Project	<b>IEEE 802.16 Broadband Wireless Access Working Group</b> < <a href="http://ieee802.org/16">http://ieee802.org/16</a> >
Title	<b>Ranging Primitive Example</b>
Date Submitted	<b>2006-11-12</b>
Source(s)	Peretz Feder - Lucent Technologies <a href="mailto:pfeder@lucent.com">[mailto: pfeder@lucent.com]</a>
Re:	
Abstract	IEEE802.16g/D5, Modifications to Figures 508 and 509
Purpose	Adoption
Notice	This document has been prepared to assist IEEE 802.16. It is offered as a basis for discussion and is not binding on the contributing individual(s) or organization(s). The material in this document is subject to change in form and content after further study. The contributor(s) reserve(s) the right to add, amend or withdraw material contained herein.
Release	The contributor grants a free, irrevocable license to the IEEE to incorporate material contained in this contribution, and any modifications thereof, in the creation of an IEEE Standards publication; to copyright in the IEEE's name any IEEE Standards publication even though it may include portions of this contribution; and at the IEEE's sole discretion to permit others to reproduce in whole or in part the resulting IEEE Standards p

Figure 508 – C-SFM-REQ (create and Set) and C-SFM-RSP (Create and Set) primitives flow, 802.16 entity initiated

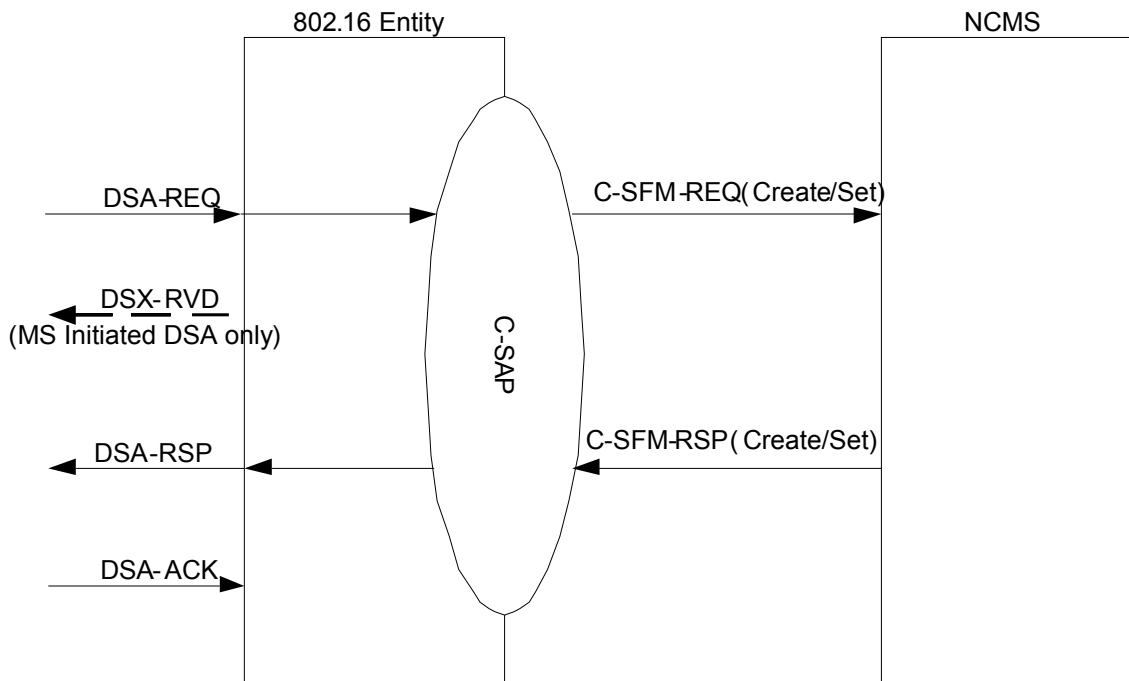
In QoS Management section, combine Figures 508 and 509 with Figures 510 and 511

Change Figures 508 and 509 as below
